Annex I Micklegate Ward

<p>11</p>	<p>Location: Junction of Nunthorpe Crescent and Nunthorpe View</p>	
<p>1 Background information (reason for proposal)</p>		
<p>Vehicles parked on the grass verges close to the junction restrict the visibility for drivers and cyclists at the junction. This is a residents parking zone, hence these vehicles will belong to residents or their visitors. The junction is approximately 75m from the end of the cul-de-sac so vehicle numbers and speeds will be very low. The bend in the road at this point helps to minimise any visibility issues. The issues here are possibly more to do with damage to the small grass verges.</p>		
<p>2 Proposed amendment to the Traffic Regulation Order</p>		
<p>Implement 10m of No waiting at any time restrictions both sides of the junction.</p>  <p>The map illustrates the proposed 10m No Waiting at any Time Restrictions (double yellow lines) at the junction of Nunthorpe Crescent and Nunthorpe View. The restrictions are shown as double yellow lines extending 10m from the junction on both sides. A key to restriction types is provided, indicating that the double yellow lines represent 'Proposed No Waiting at any Time Restrictions (

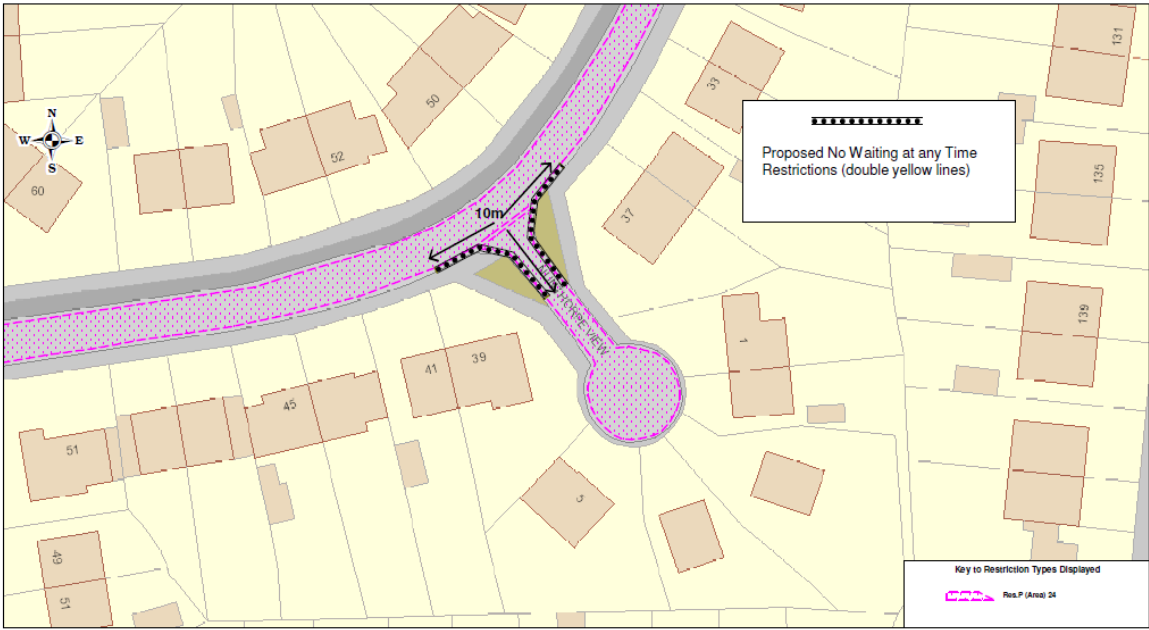
<p>3 Objections received</p>		
<p>We have received two requests for a shortened length of restriction on Nunthorpe Crescent from residents on Nunthorpe Crescent.</p>		
<p>Objections/Concerns raised</p> <p>We do not want the double yellow lines across our driveway. Is it possible the lines could stop at the southern end of the dropped kerb at 37 Nunthorpe Crescent.</p>	<p>Officer Comments</p> <p>The main complaint was one of regular parking on the grass verge areas causing obstructive sight lines for cyclists and causing verge damage.</p>

We believe reducing the extent of double yellow lines along Nunthorpe Crescent would not be detrimental to the safety improvements sought. Both streets are no-through road with limited traffic and a 20mph speed limit. The resident parking area prevents indiscriminate and obstructive parking. We do not have an off-street parking area and park our car on Nunthorpe Crescent adjacent to our property. We believe we park our car in a safe and considerate manner. (Requesting a distance of 6.5m from centre line.)

Because this area has limited traffic and low speeds, we believe we can reduce the length of restrictions as requested.

A 7m restriction would cover the verge extent in both directions.

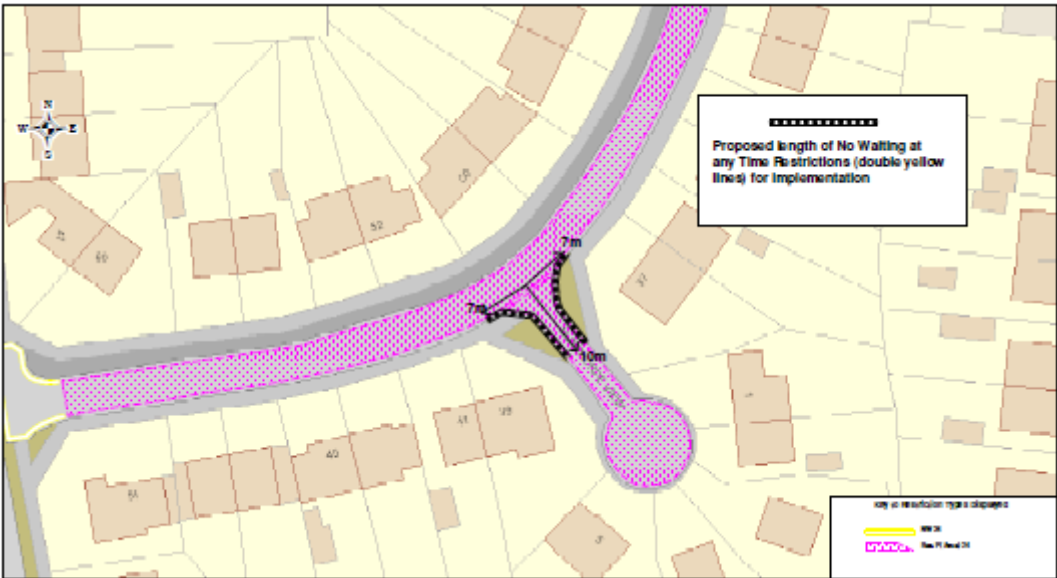
- a) Implement the proposal as advertised
This is not the recommended option because we are able to amend the proposal without significant detriment to the overall objectives of the scheme.
- b) Uphold the objections and implement an amended restriction as outlined in the plan below.

This is the recommended option because we are able to take the views of residents into account without compromising road safety.

Option(b):
Implement an amended restriction with shorter lengths being applied on the Nunthorpe Crescent elevations.
